NAME	DATE	TITLE: Overall View			
DRAWN	PMG	1/22/2020				
CHECKED						
ENG APPR.						
MFG APPR.						
Q.A.			SIZE DWG. NO. REV B 2 ?			
COMMENTS:						
DO NOT SCALE DRAWING			SCALE: 1:20		WEIGHT:	SHEET 2 OF 31

NAME	DATE	TITLE: Dado		
DRAWN	PMG	1/22/2020			
CHECKED	RR	2/2/2020			
ENG APPR.					
MFG APPR.	RR	6/8/2020			
Q.A.			SIZE B		
COMMENTS:					
DO NOT SCALE DRAWING			DWG. NO. 4		REV A
			SCALE: 1:5		WEIGHT:

NAME	DATE	TITLE: Art		
DRAWN	PMG	1/22/2020			
CHECKED	RS	2/22/2020			
ENG APPR.					
MFG APPR.	RS	3/1/2020			
Q.A.	PMG	4/1/2020			
COMMENTS:			SIZE B	DWG. NO. 28	REV A
DO NOT SCALE DRAWING			SCALE: 1:20 WEIGHT:		SHEET 28 OF 31

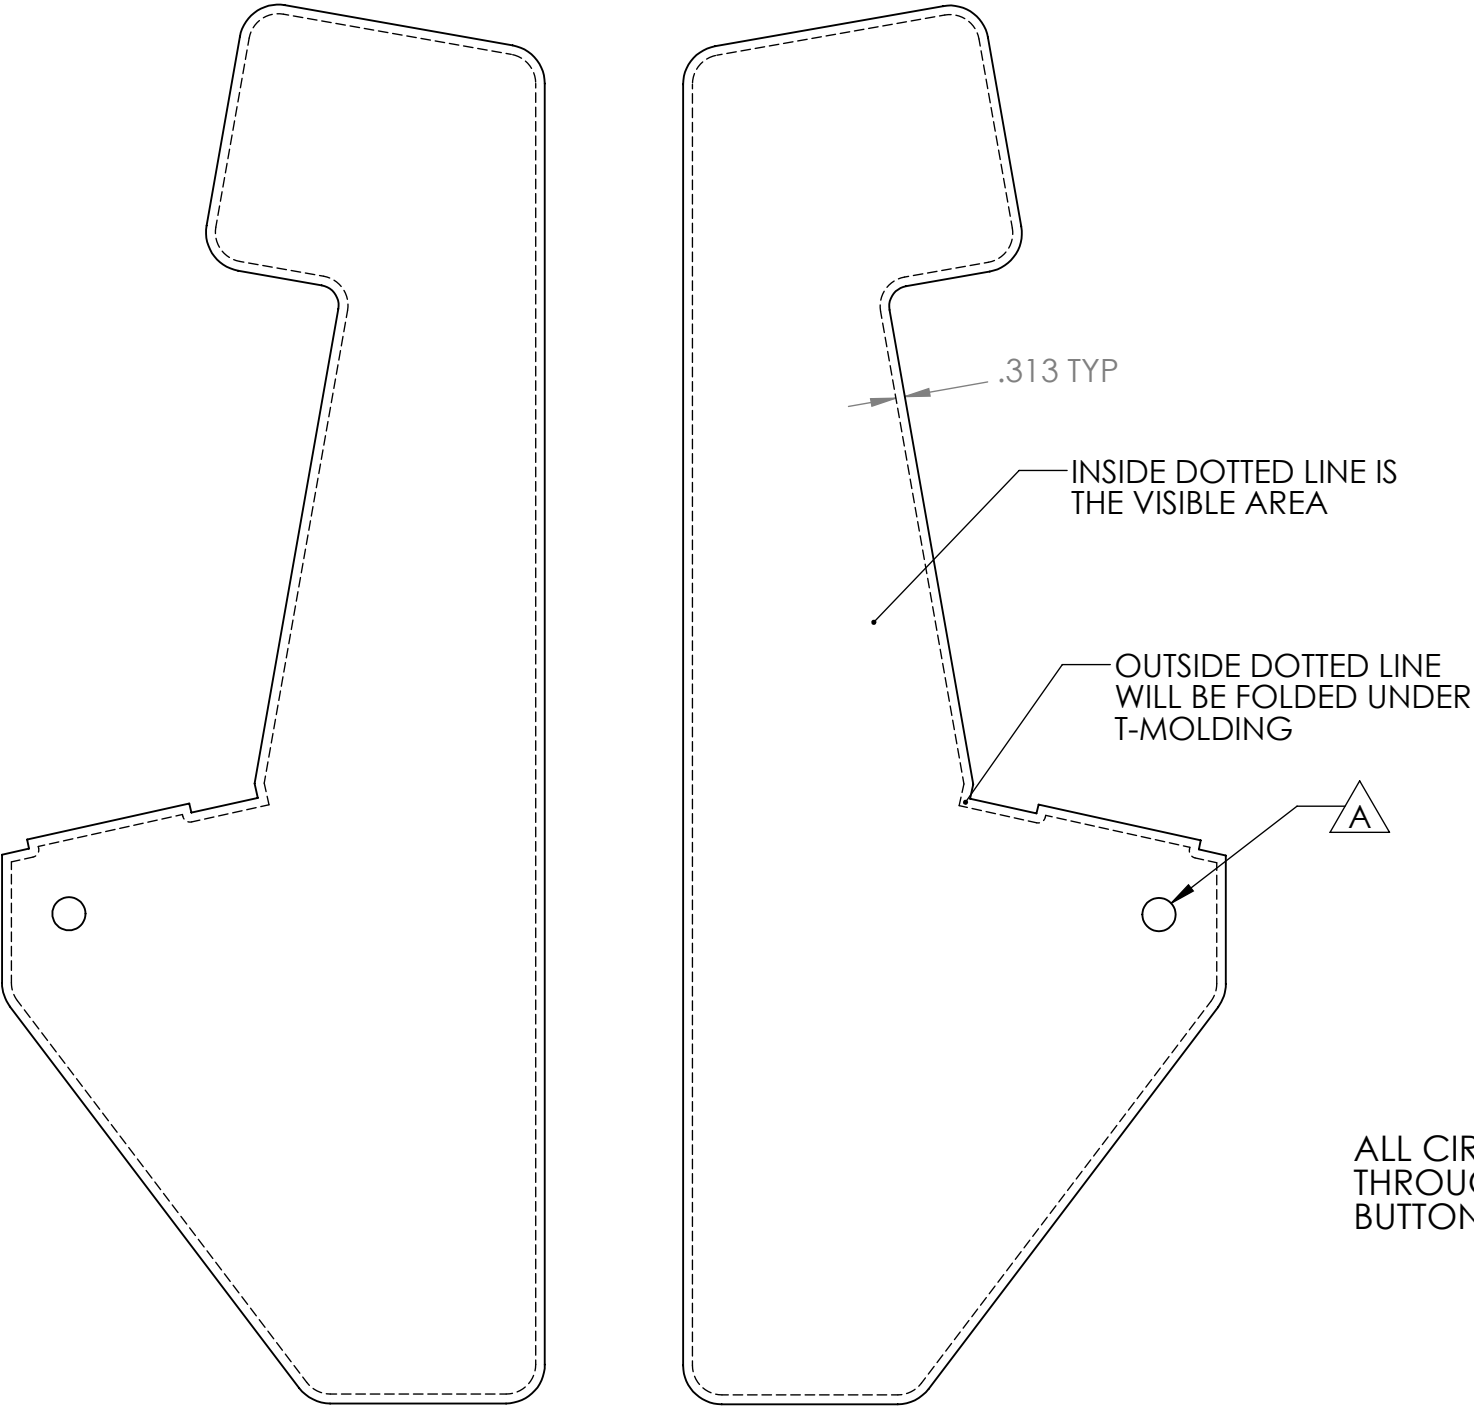
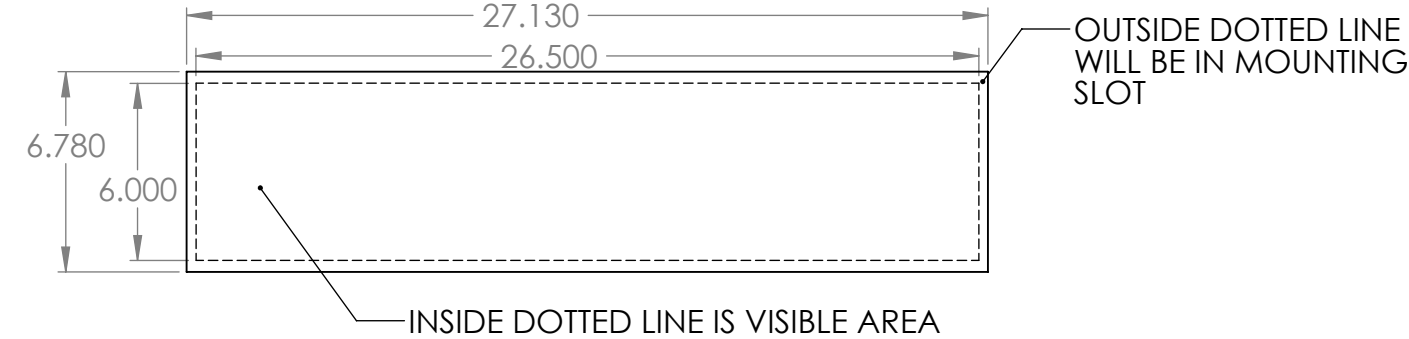
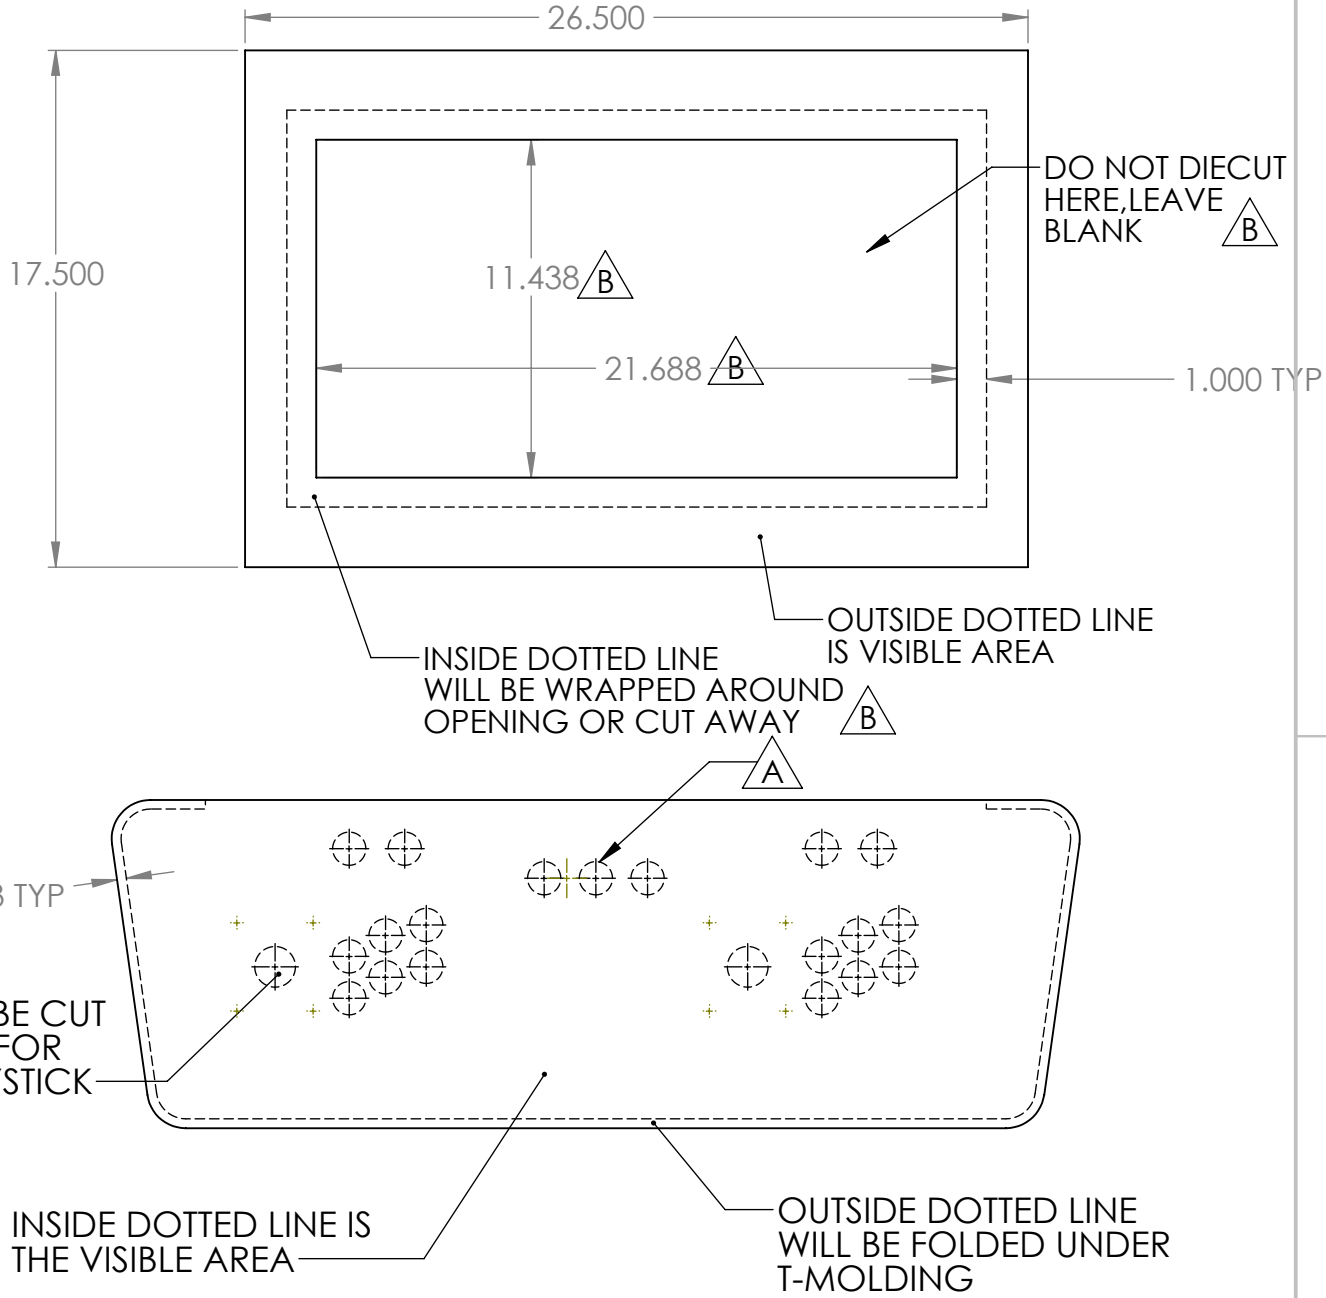
REVISIONS				
ZONE	REV.	DESCRIPTION	DATE	APPROVED
A1, B3	A	Control Panel - Changed Middle Buttons from 4x to 3x, Sides - Added Buttons for Pinball Games	2/22/2020	PG
B1	B	Changed Cutout to Blank Area, Reduced Blank Area Size, Changed Note About inside Dotted Line	11/4/2020	PG

NAME	DATE	TITLE: 5/8" Panel		
DRAWN	PMG	1/22/2020			
CHECKED	RR	2/2/2020			
ENG APPR.					
MFG APPR.	RR	6/8/2020			
Q.A.			SIZE DWG. NO. REV B 30 A		
COMMENTS:					
DO NOT SCALE DRAWING			SCALE: 1:20 WEIGHT: SHEET 30 OF 31

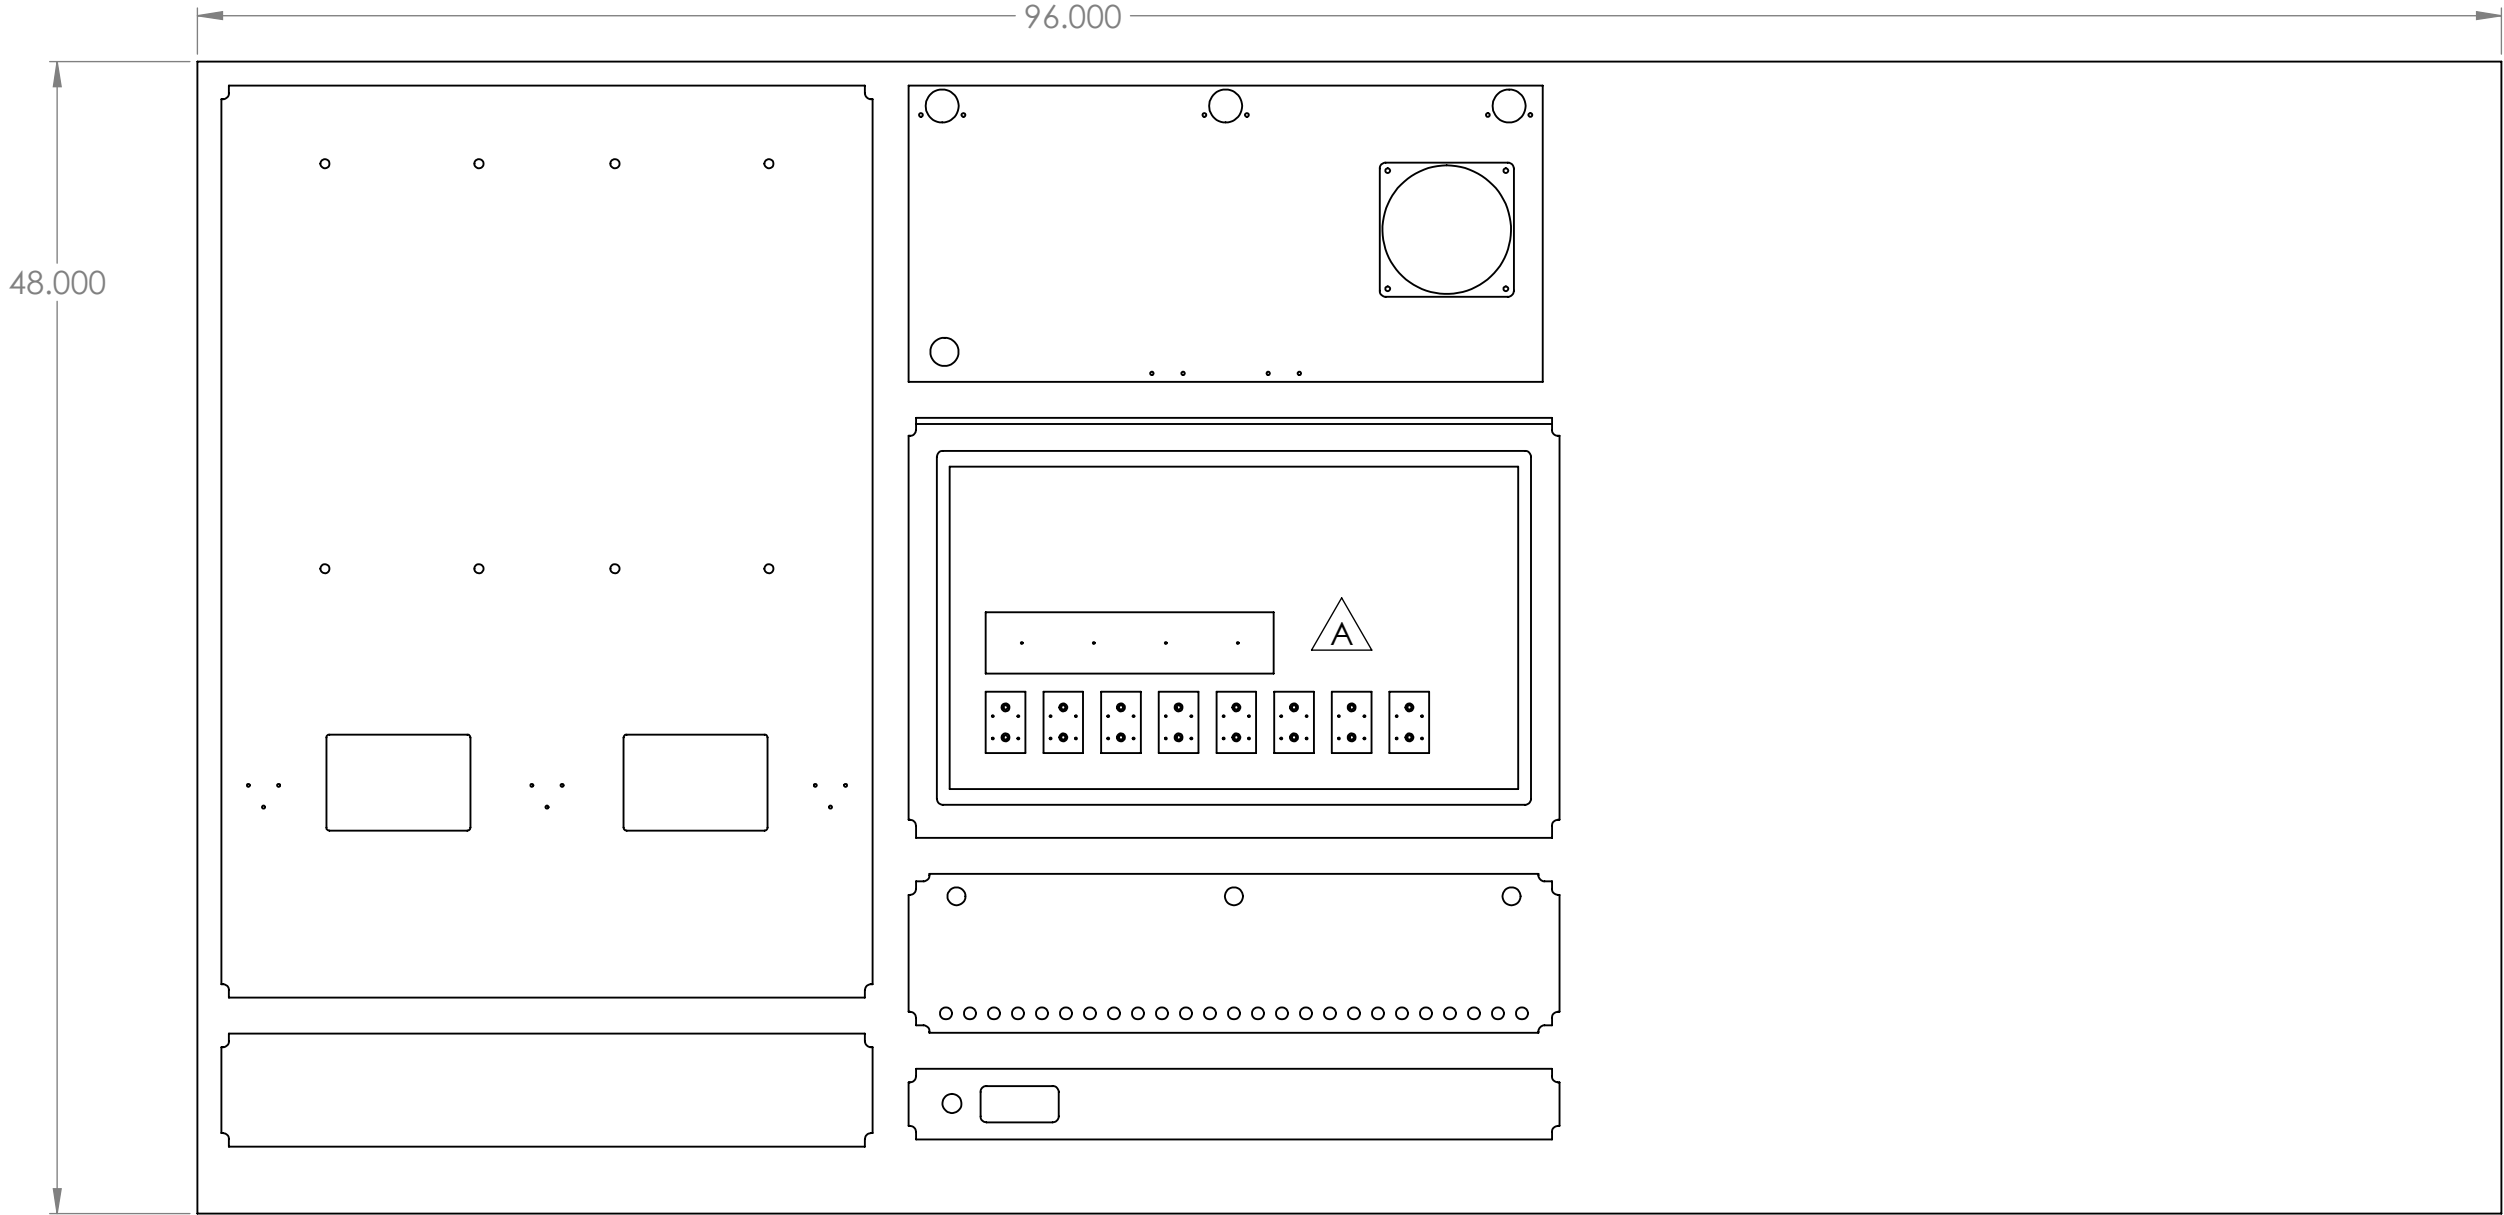
REVISIONS				
ZONE	REV.	DESCRIPTION	DATE	APPROVED
B3	A	Removed Latch Braces, Added 6x Latch Mounts and Front Brace	11/4/2020	PG
